**Municipality of Anchorage  
Planning Division  
MEMORANDUM**

**SUBJECT:** Case 2016-0023; Nordstrom Rack in Sears Mall  
Amended Site Plan Review

**APPLICANT:** Sears Roebuck and Company

**RECOMMENDATION SUMMARY:** Approval with conditions

700 E. Northern Lights  
May, 2014

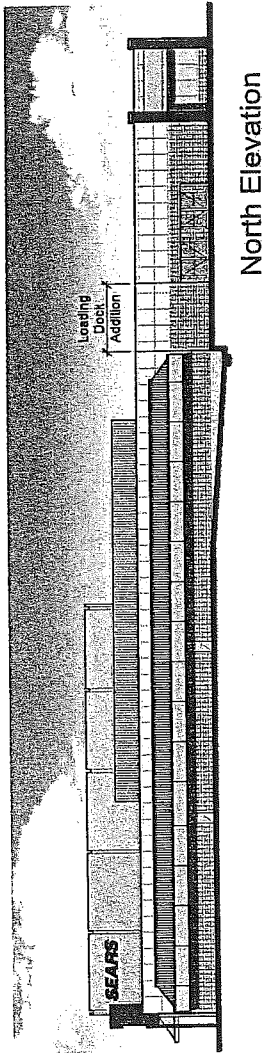
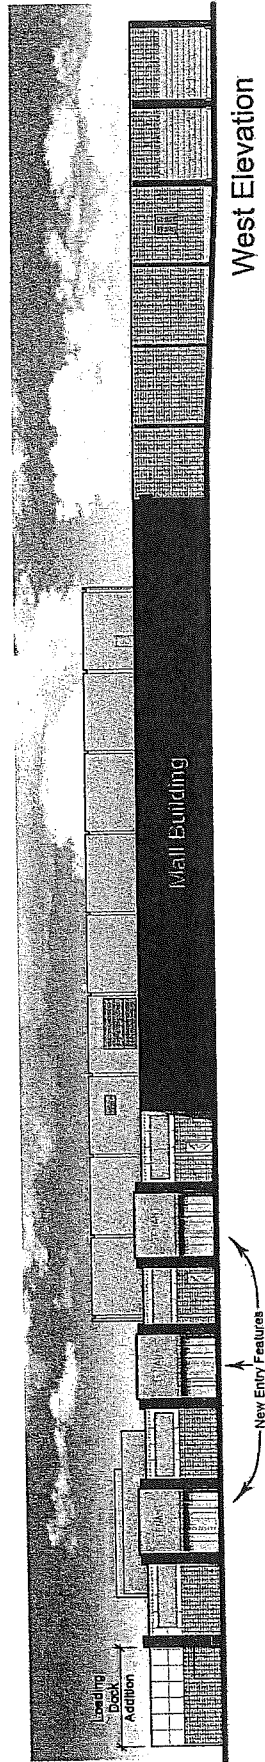
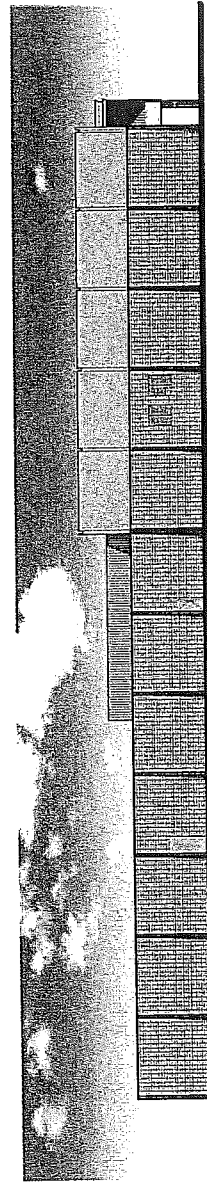
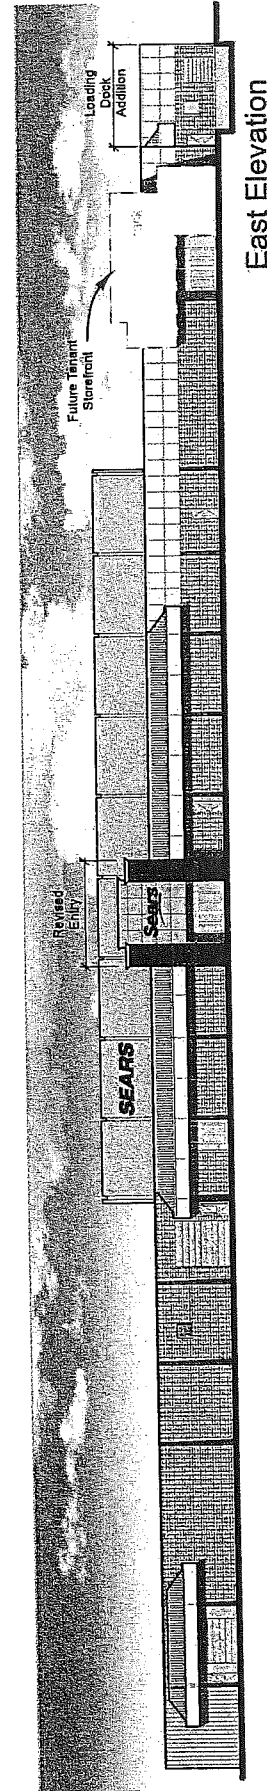
The east side mall entry will have a new entry feature that will project out in addition to an existing recessed entry. This feature should provide some degree of weather protection. The north, east, and west sides of the existing Sears store have awnings projecting over the sidewalks, which is in conformance with this section of Title 21. The awnings should be kept in place to protect pedestrians from the elements.

The exterior renovation is an improvement from the existing façade along the north and west elevations. The upper portion of the exterior walls along the east and north elevations are to be clad in new exterior insulation and finish panels, however the height is above that to provide visual interest at the pedestrian level and involves removing the existing awning. The northwest corner will have views into the storefront from the proposed window which breaks up the mass effect and allows for the interior to be visible to passerby during the winter months. The existing awning canopy does a decent job of reducing the mass effect of the building wall and provides protection from the elements.

5. Submit a copy of the updated elevation plan to show an overhang awning along at least sixty (60) percent of the east elevation building length.
6. Submit a landscape plan to include the landscape budget required by AMC 21.55.130 towards improving landscaping along Northern Lights Boulevard.

DWG NO: C102  
SHEET 3 OF 87

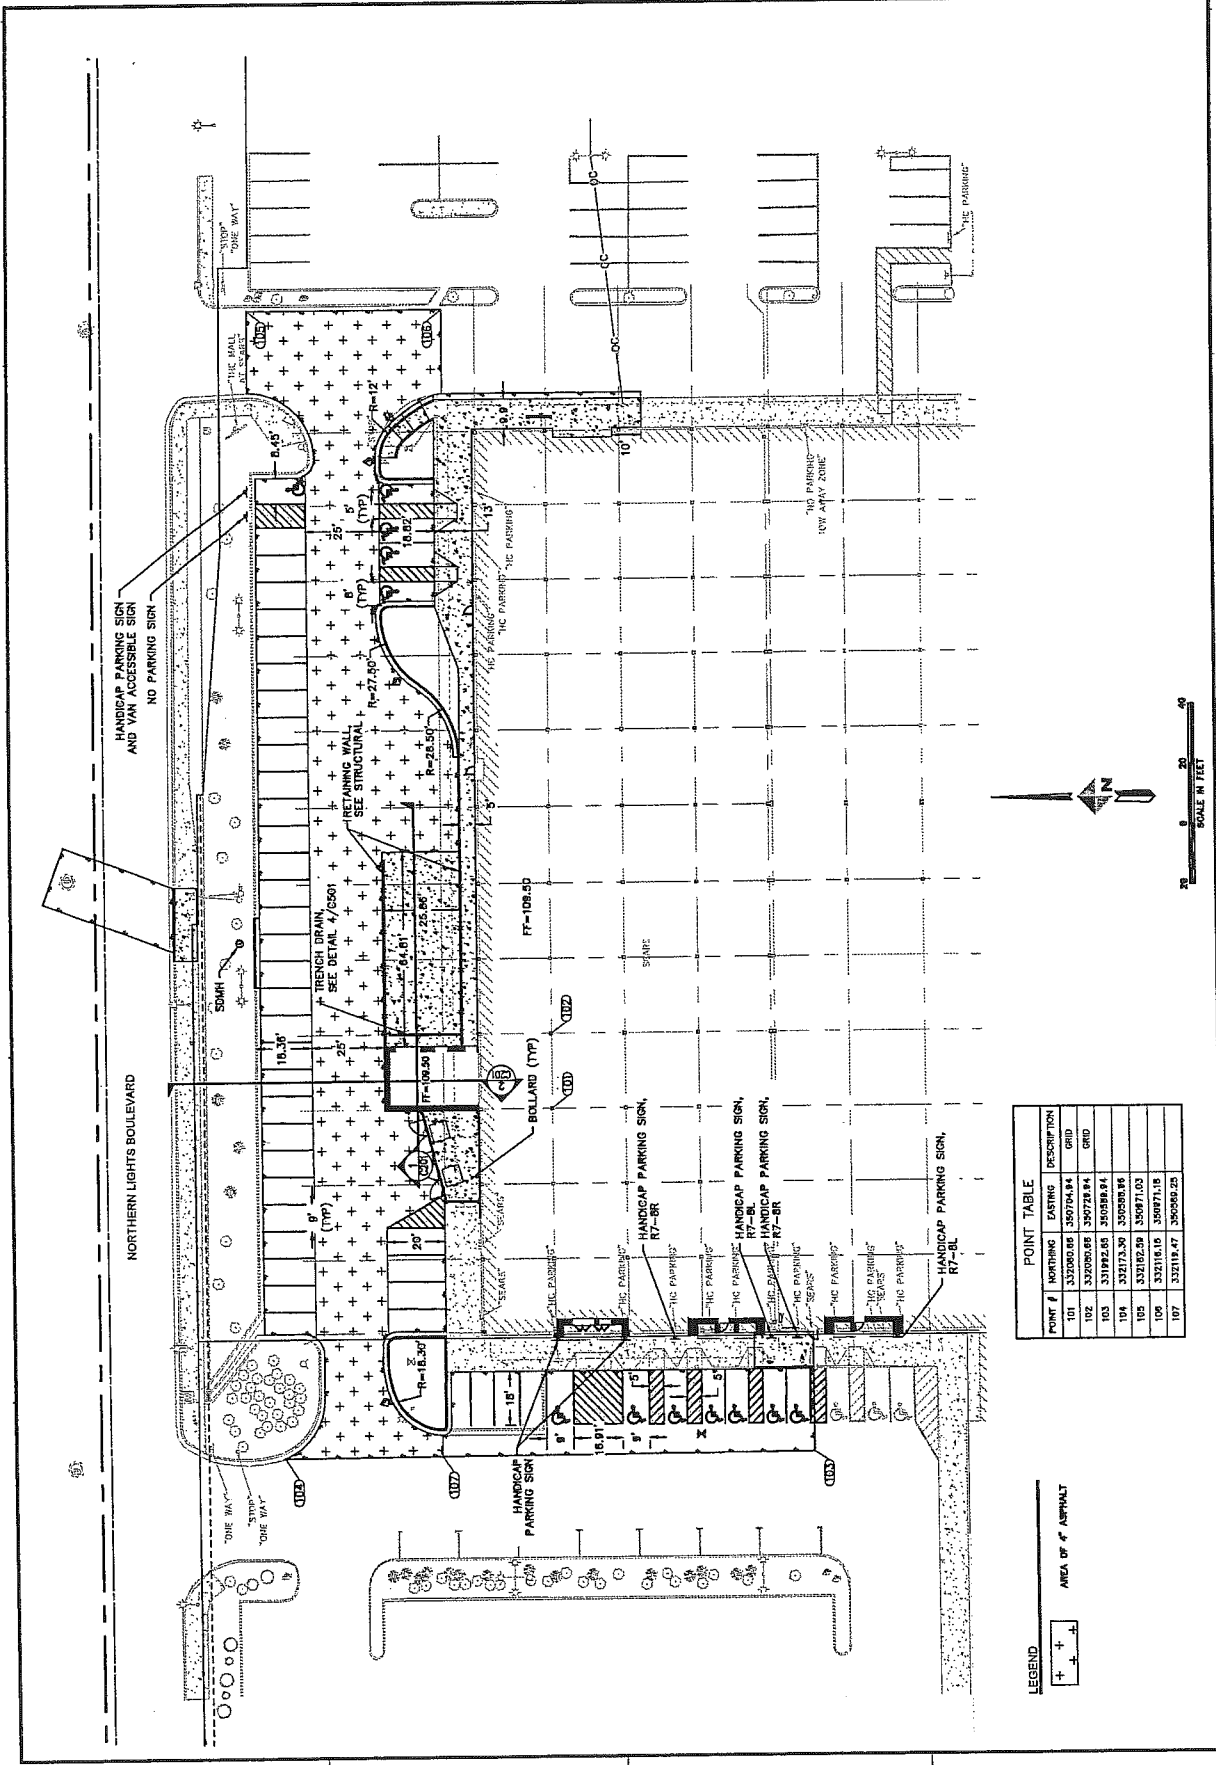
west most driveway has a tree blocking the driver's ability to see traffic as they exit onto the roadway. The east driveway looks to have a tree that might impact driver vision. As such, we require that the ADOT&PF sight distance triangles found in the Alaska Highway Pre-construction Manual page 1160-17, figure 1160-8 be added to the site plan for access points onto Northern Lights Boulevard. Any landscaping that falls within these sight triangles must be removed.

The non-motorized transportation coordinator provided a comment that the Sears mall has a lack of pedestrian access from the Northern Lights Boulevard sidewalk to the west and eastern entry doors where these improvements are proposed. We request a walkway from the sidewalk thru the planting beds to the doorways on the west and east side. Since work is being done in the parking lot this work is appropriate and will create easier pedestrian access.

3. Submit a copy of the updated site plan that shows the required sight distance triangles per ADOT&PF standards. Verify the removed trees are replaced on a one-to-one basis.

4. Amend the site plan to show pedestrian walkway striping for pedestrian access to the east entry doors from the sidewalk along Northern Lights Boulevard.
